Puyallup Mazda Service Drive-Thru Expansion

**Puyallup Mazda -
Customer Service
Drop-Off
Expansion**

Permit Set

SOUTH ELEVATION

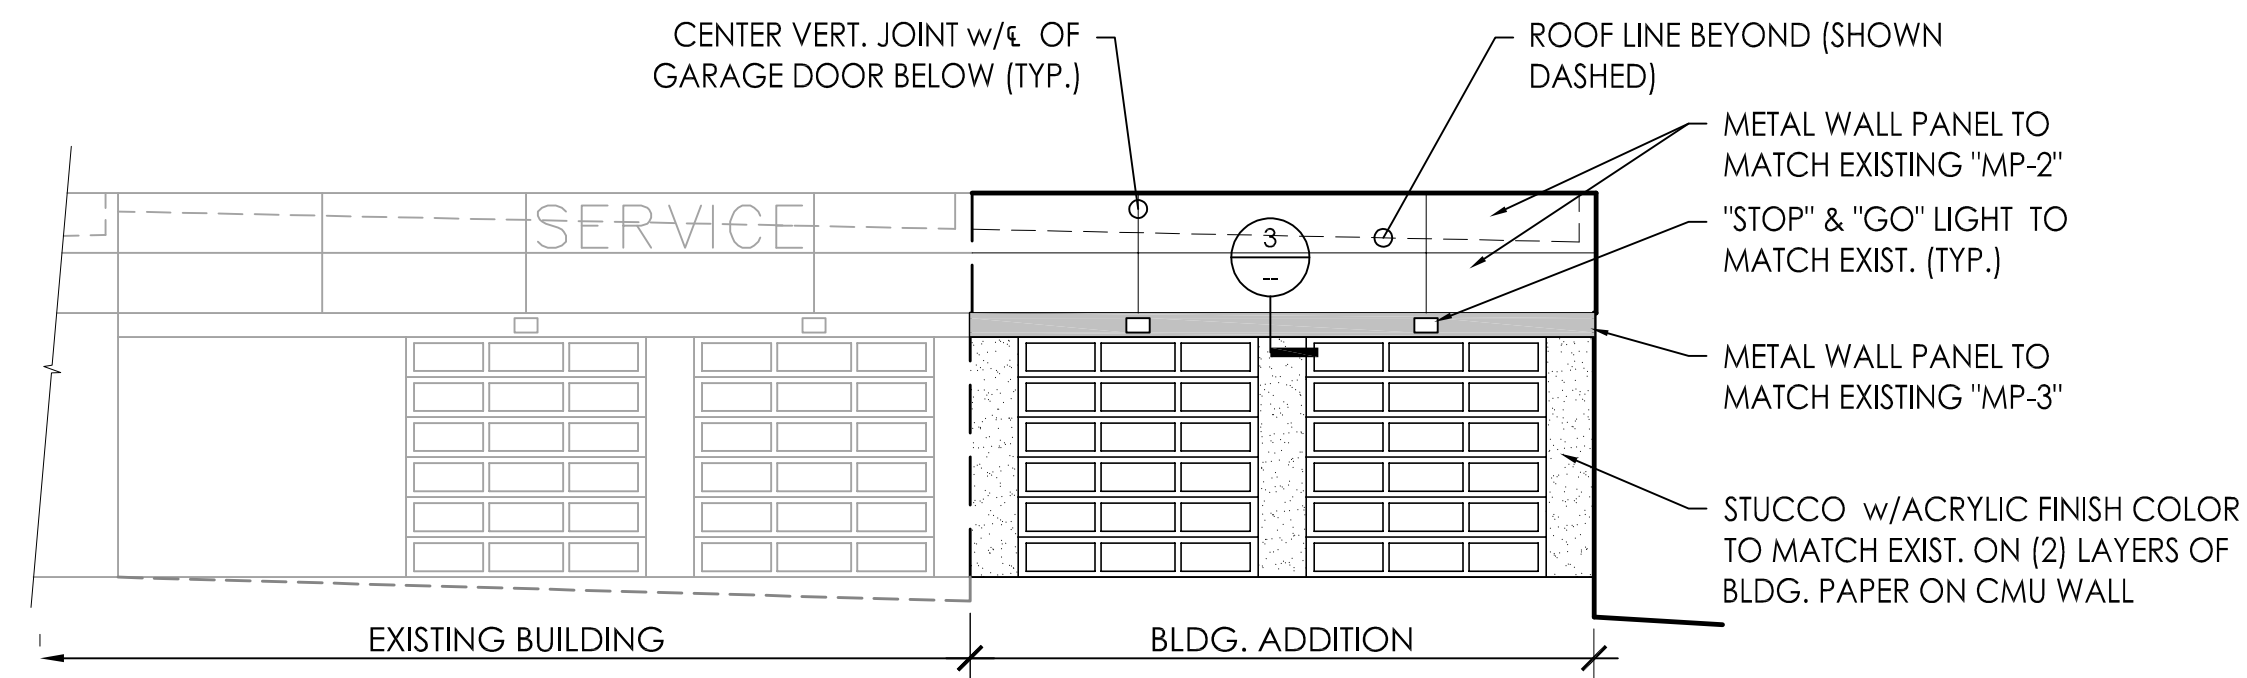
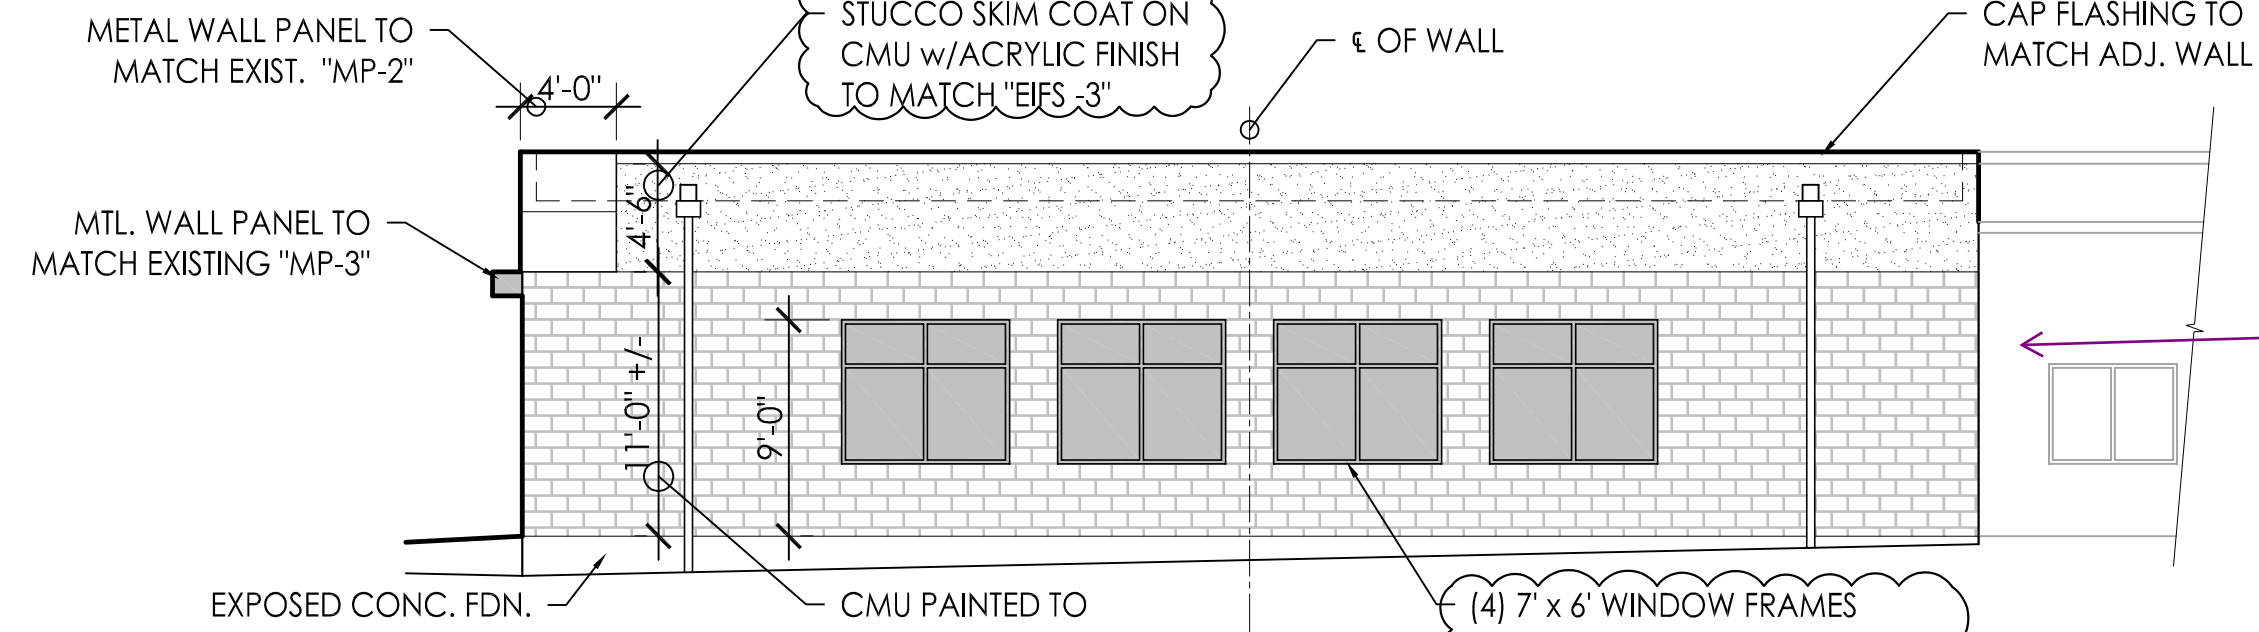
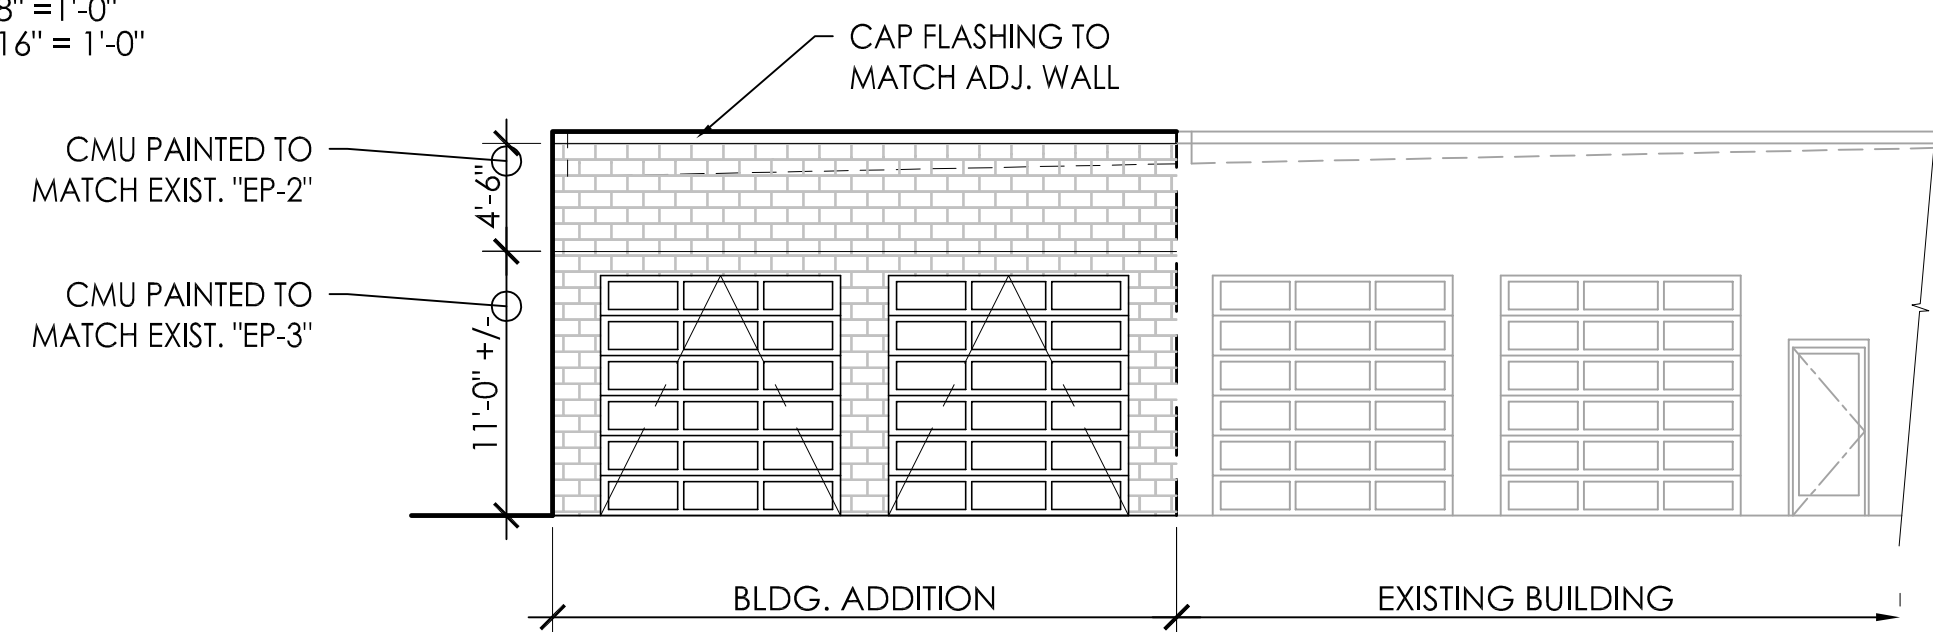
South elevation is visible from a public street and is at least 400SF. This wall will be required to use at least 400SF of the area of the exterior wall or techniques for non-residential design review (or building wall facade articulation (PMC 20.26.300 (2)(a)).

Reflect chosen methods on this plan set and updated design review worksheet.
